SERVICE BULLETIN 2008 – 05

TO: ALL CORRECT CRAFT DEALERS
RE: FCT2 (Titan) HINGE ASSEMBLY

October 27, 2008

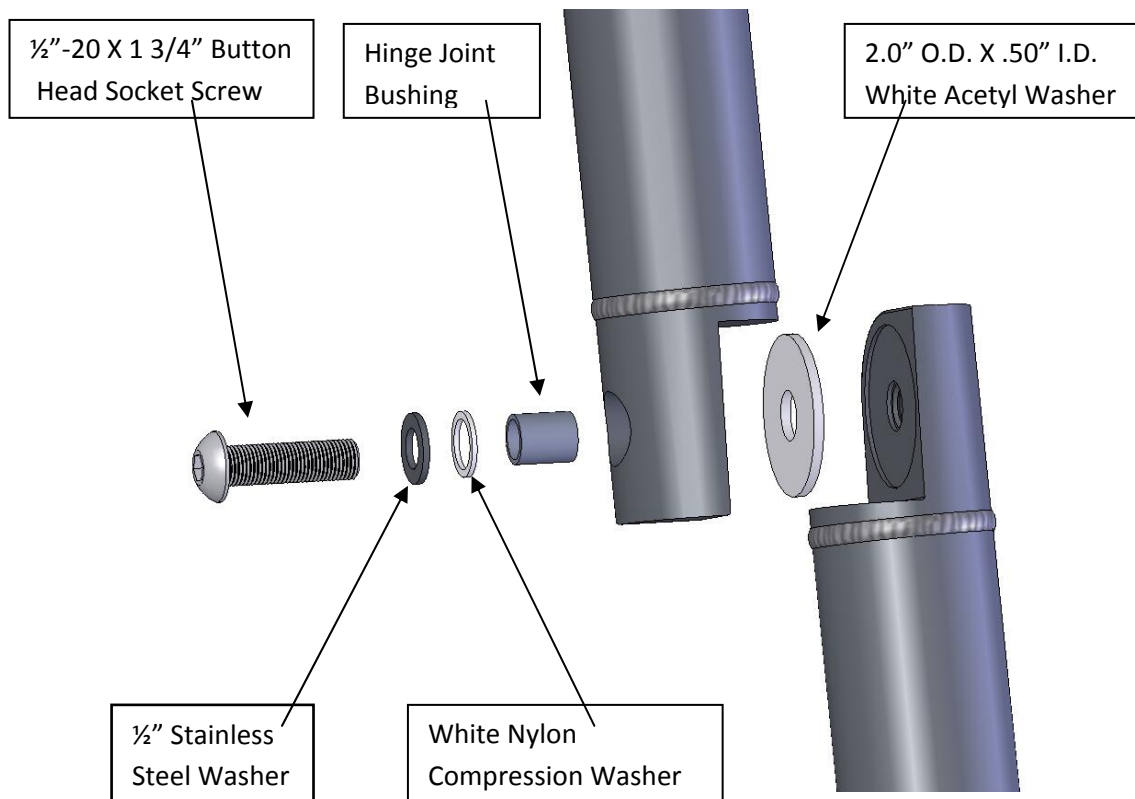
We have heard of a few instances of the FCT2 hinge joint becoming loose. If this issue is brought to your attention:

1. **Confirm the proper placement of the hinge hardware as pictured below.**
2. If the hardware is loose, apply Loctite "Blue" 242 to the socket screw and tighten to 40 foot pounds.

NOTE: The 1/2" Stainless Steel washer should be assembled to the outside of the White Nylon Compression Washer. This allows the White Nylon Compression Washer to be trapped and compressed into the hinge counter bore. Failure to assemble the Hinge Joints in this way will cause failure of the White Nylon Compression Washer; this may possibly reduce the performance of the Tower shortening the life of the hinge joint.
